**ENCLOSURE -
FIRST TECHNICAL NOTICE OF DEFICIENCY REGARDING JANUARY 12, 2010
AMENDMENT APPLICATION FOR LICENSE NO. R04100**

The Texas Commission on Environmental Quality (TCEQ) comments regarding deficiencies and requested action items are grouped under each applicable appendix of the minor amendment application as submitted.

Figure 1. Map showing BEG geophysical lines 1 through 8, planned excavations within the FWF and CWF, wells with OAG water in May 2009, and proposed boring locations.

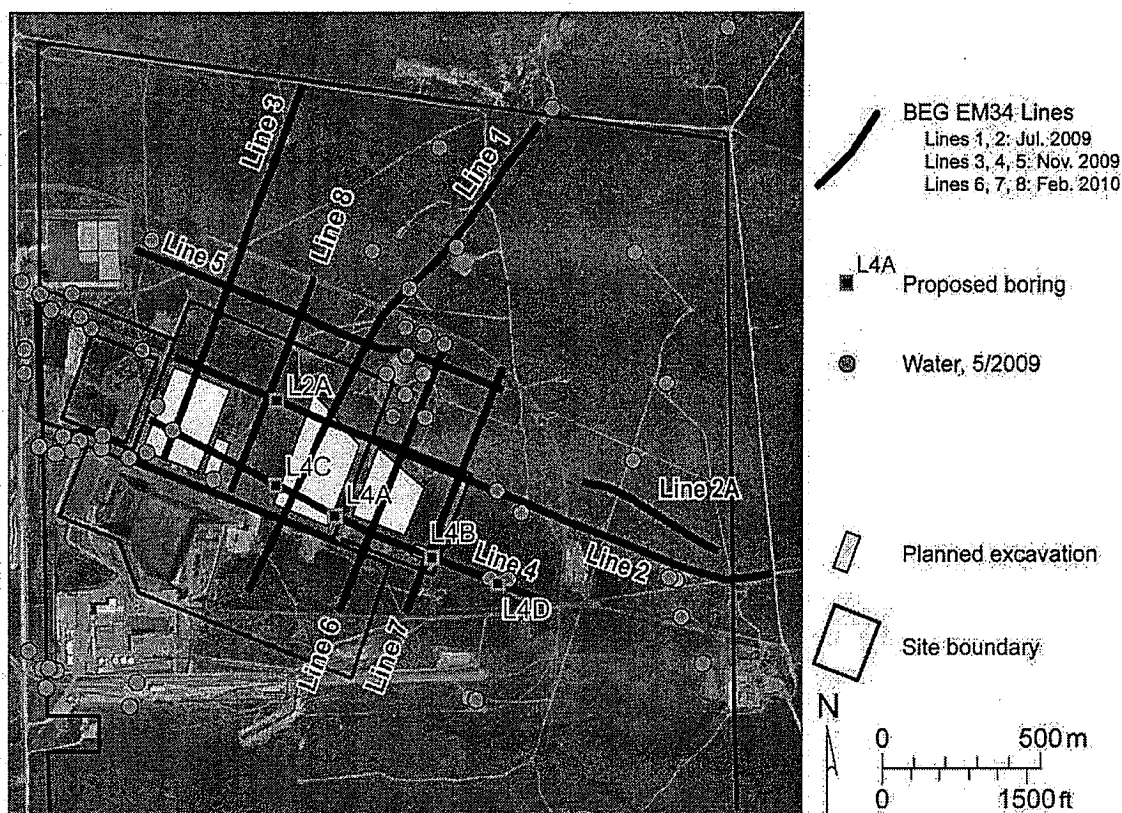
2. Regarding LC 53.B. Discussion at the March 29, 2010 at TCEQ, WCS indicated its intent to drill a series of as many as five new boreholes to a depth of 30 meters along the red-bed ridge. Please see Figure 1 below for a map of these locations - In descending priority order, these include (a) three boreholes along EM line 4 in the FWF and CWF footprints (L4A, L4B, and L4C), (b) one borehole along EM line 4 in the small playa east of the CWF (L4D), and (c) one borehole near the intersection of EM lines 2 and 8 in the middle part of the FWF (L2A). Unless samples and cores are available from acceptable nearby boreholes, each of these boreholes should be sampled within the OAG section and cored within the Triassic section.

TCEQ and/or its contractor intends to log boreholes along the red-bed ridge (as well as suitable nearby monitoring wells) with natural gamma and electrical conductivity probes for comparison with lithologic descriptions, samples, and geophysical data. This work should be done as soon as possible in order to have additional information prior to excavation of the disposal units. If WCS proposes alternative wells or boreholes to be logged, such as utilizing monitoring wells already planned for the CWF and FWF, please submit those alternatives be reviewed and approved by TCEQ.
